APPENDIX A – Part H Language for Enforcement of Reasonable Progress Determinations

Regional Haze – Second Planning Period
SIP Evaluation Report:

The following is part of the Technical Support Documentation for the Second Planning Period of the Regional Haze SIP (aka the Visibility SIP). This document specifically serves as an evaluation of the Ash Grove Cement Company facility.

**RE: Ash Grove Cement Company, Leamington Plant,
Four-Factor Analysis – Supplemental Information**

Figure 3. Annual facility wide NO_x emissions from PacifiCorp's Hunter Power Plant, 2008-2020 (CAMD 2020)

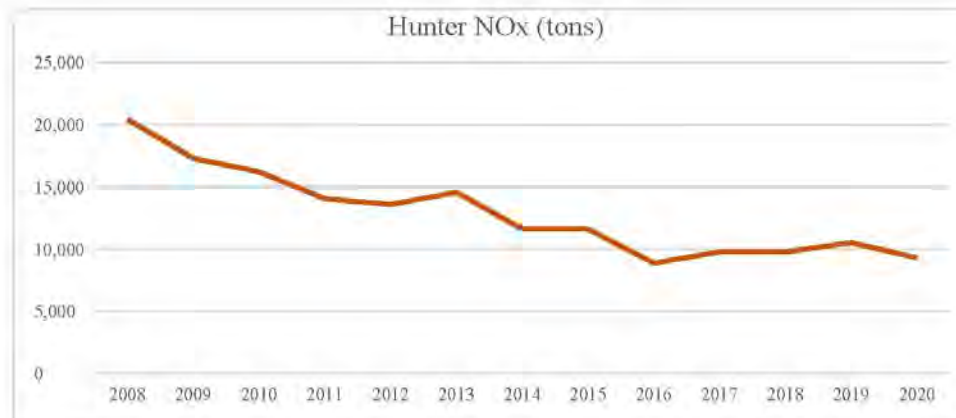
Visibility impairment is a short-term problem. Any emission limit that does not limit short-term emissions effectively allows fluctuations that could adversely impact a visitor's experience. Haze-causing emissions should be controlled to the maximum reasonable extent at all times.

Although the RP NO_x limits proposed by UDAQ represent significant reductions versus the current PAL NO_x limits for Hunter and Huntington, they would allow NO_x emissions to increase (4% at Hunter and 12% at Huntington) versus the most recent five-year average. Emissions data show that since 2015 NO_x emissions at Hunter have only exceeded the proposed RP limit of 10,001 tons/year once (in 2019).

Figure 4. Annual facility wide NO_x emissions from PacifiCorp's Huntington Power Plant, 2008-2020 (CAMD 2020)

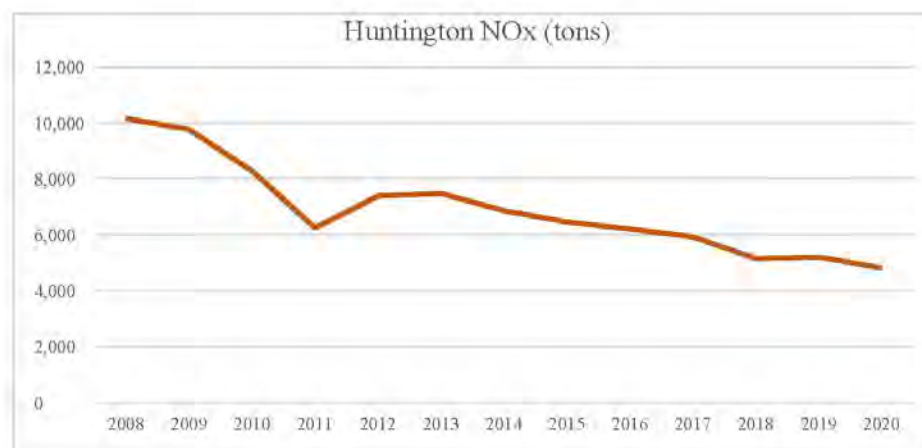
Likewise, NO_x emissions at Huntington have not exceeded the proposed RP limit of 6,091 tons/year (by 2028) since 2016.

UDAQ RP emission limits, while adequate to prevent backsliding, fall well short of the NO_x emission reduction potential that requirement of SCR or SNCR controls at Hunter and Huntington EGUs could achieve. We recommend that UDAQ reconsider opportunities to make real NO_x emission reductions at the Hunter and Huntington power plants by requiring technically

Figure 5. Hunter facility-wide annual SO₂ + NO_x emissions (1995-2020) (CAMD 2020)

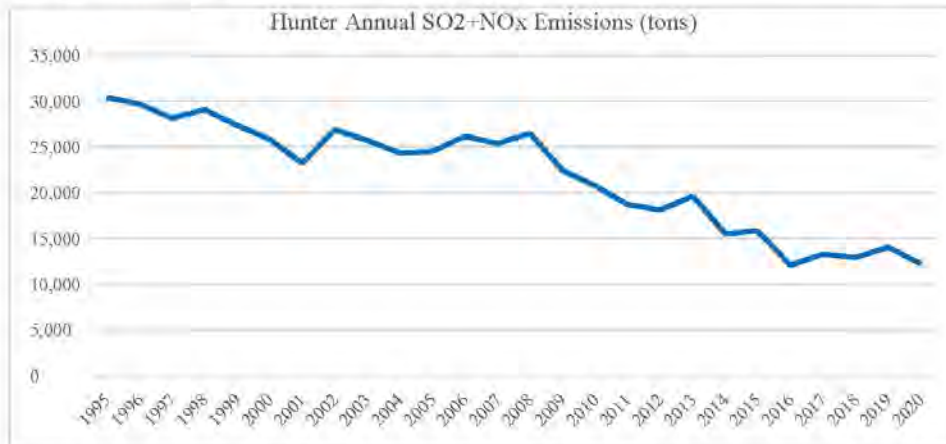
We agree with UDAQ's rejection of the plantwide combined NO_x + SO₂ emission limit of 17,000 tons/year proposed by PacifiCorp for Hunter as a control measure (RPEL). This measure would not constitute actual emission reductions. As our review illustrates, the sum of Hunter's SO₂ + NO_x emissions has not exceeded the proposed RPEL of 17,000 tons/year since 2014 (see Figure XX). The most-recent five-year averages are 3,269 tons SO₂ and 9,643 tons NO_x and 12,912 tons combined.

Figure 6. The Hunter Unit 3 calculated average SO₂ emission rate (2009-2020) is increasing. (CAMD 2020) (CAMD 2020)

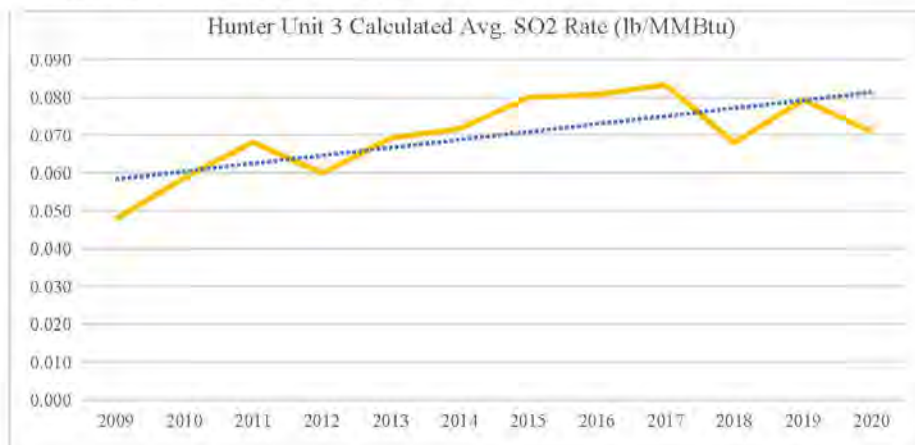
scrubbers are achieving 90% - 92% SO₂ control. Further, the scrubber on Hunter Unit 3 has shown a trend of increasing SO₂ emission rates since 2009 as shown below. It is reasonable to expect that the scrubber optimization would minimally return the emission rate to levels that have been demonstrated in the recent past.

PacifiCorp estimated that meeting its suggested RPEL would require scrubbing to a SO emission rate of 0.032 lb./MMBtu on Units 1, 2, and 3 costing \$301,000/year in O&M costs for a total annualized cost of \$301,000/year for Units 1 and 2 and \$311,000/year in O&M costs for a total annualized cost of \$311,000/year for Unit 3. This suggests that scrubber upgrades and efficiencies are both known and achievable. Further, PacifiCorp estimates reveal that SO₂ emissions could be reduced by:

Figure 7. Hunter Unit 1, calculated annual SO₂ + NO_x emissions (CAMD 2020)

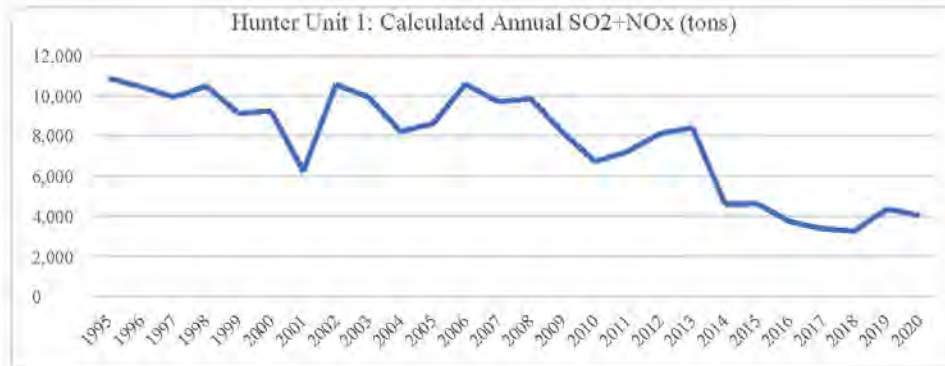
The 2016 – 2020 sum of the average annual SO₂ and NO_x emissions from Hunter Unit 1 is 3,753 tons/year. The sum of Hunter Unit 1's SO₂ + NO_x emissions has not exceeded the proposed RPEL 4,824 tons/year threshold for this unit since 2013 as shown below.

We find that 74% of recent Total SO₂ + NO_x emissions from Hunter Unit 1 have been NO_x. 74% of the Hunter Unit 1 PAL is 4,711 tons. Based upon Hunter Unit 1's 0.26 lb/mmBtu NO_x limit, we adjusted Hunter Unit 1 heat input to yield approximately 4,711 tons of NO_x; this formed the baseline for our analysis of the cost-effectiveness of adding SNCR or SCR versus the existing PAL.

Figure 8. Hunter Unit 2, calculated annual SO₂ + NO_x emissions (CAMD 2020)

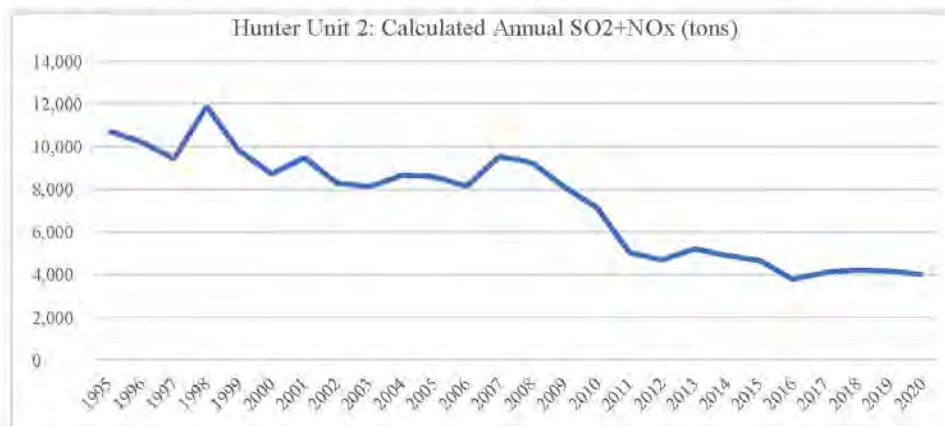
The 2016 – 2020 sum of the average annual SO₂ and NO_x emissions from Hunter Unit 2 is 4,047 tons/year. The sum of Hunter Unit 2's SO₂ + NO_x emissions has not exceeded the proposed RPEL 4,824 tons/year threshold since 2014 as shown below.

We find that 70% of recent Total $\text{SO}_2 + \text{NO}_x$ emissions from Hunter Unit 2 have been NO_x . 70% of the Hunter Unit 2 PAL is 4,471 tons. Based upon Hunter Unit 2's 0.26 lb/mmBtu NO_x limit, we adjusted Hunter Unit 2 heat input to yield approximately 4,471 tons of NO_x ; this formed the baseline for our analysis of the cost-effectiveness of adding SNCR or SCR versus the existing PAL.

Figure 9. Hunter Unit 3, calculated annual $\text{SO}_2 + \text{NO}_x$ emissions (CAND 2020)

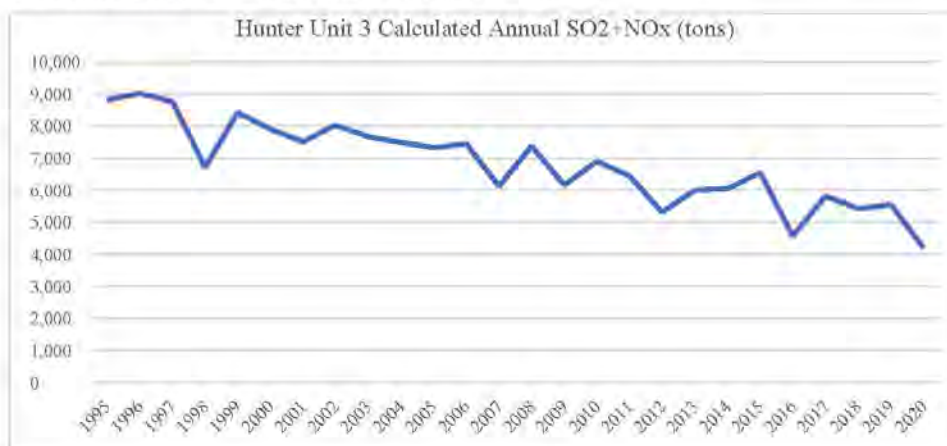
The 2016 – 2020 sum of the average annual SO_2 and NO_x emissions from Hunter Unit 3 is 5,112 tons/year. The sum of Hunter Unit 2's $\text{SO}_2 + \text{NO}_x$ emissions has not exceeded the proposed RPEL 7,352 tons/year threshold since 2008 as shown below.

We find that 78% of recent Total $\text{SO}_2 + \text{NO}_x$ emissions from Hunter Unit 3 have been NO_x . 78% of the Hunter Unit 3 PAL is 4,972 tons. Based upon Hunter Unit 3's 0.34 lb/mmBtu NO_x limit, we adjusted Hunter Unit 3 heat input to yield approximately 4,972 tons of NO_x ; this formed the baseline for our analysis of the cost-effectiveness of adding SNCR or SCR versus the existing PAL.

Figure 10. Huntington facility wide annual SO₂ + NO_x emissions (1995-2020) (CAMD 2020)

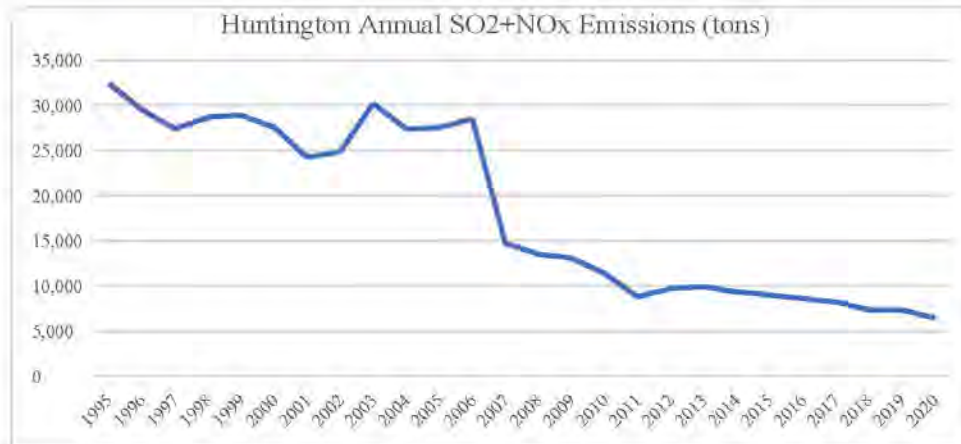
We agree with UDAQ's rejection of the plantwide combined NO_x + SO₂ emission limit of 10,000 tons/year proposed by PacifiCorp for Huntington as a control measure (RPEL). This measure would not constitute actual emission reductions. As our review illustrates, the sum of Huntington's SO₂ + NO_x emissions has not exceeded the proposed 10,000 tons/year limit since 2010 as shown below. The most-recent five-year averages are 2,124 tons SO₂ and 5,463 tons NO_x and 7,586 tons combined.

Figure 11. Huntington Unit 1, calculated annual SO₂ + NO_x emissions (CAMD 2020)

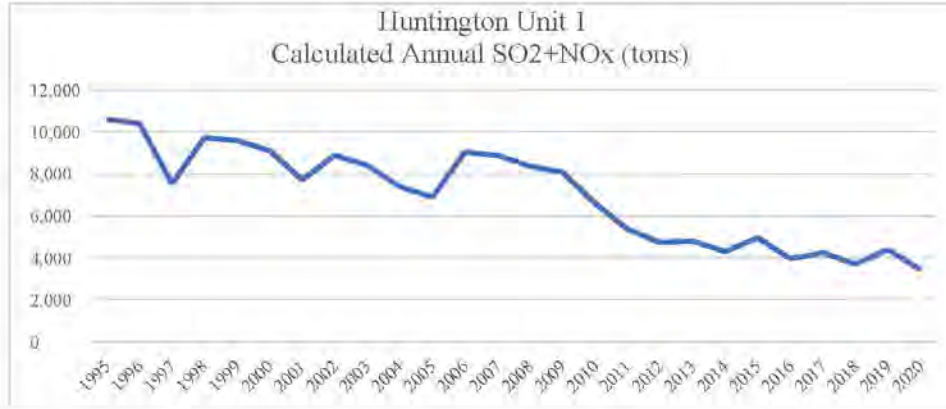
The 2016 – 2020 sum of the average annual SO₂ and NO_x emissions from Huntington Unit 1 is 3,939 tons/year. The sum of Huntington Unit 1's SO₂ + NO_x emissions has not exceeded the proposed 5,000 tons/year threshold since 2011 as shown below.

We find that 70% of recent Total SO₂ + NO_x emissions from Huntington Unit 1 have been NO_x. 70% of the Huntington Unit 1 PAL is 3,867 tons. Based upon Huntington Unit 1's 0.26 lb/mmBtu NO_x limit, we adjusted Huntington Unit 1 heat input to yield approximately 3,867 tons of NO_x; this formed the baseline for our analysis of the cost-effectiveness of adding SNCR or SCR versus the existing PAL.
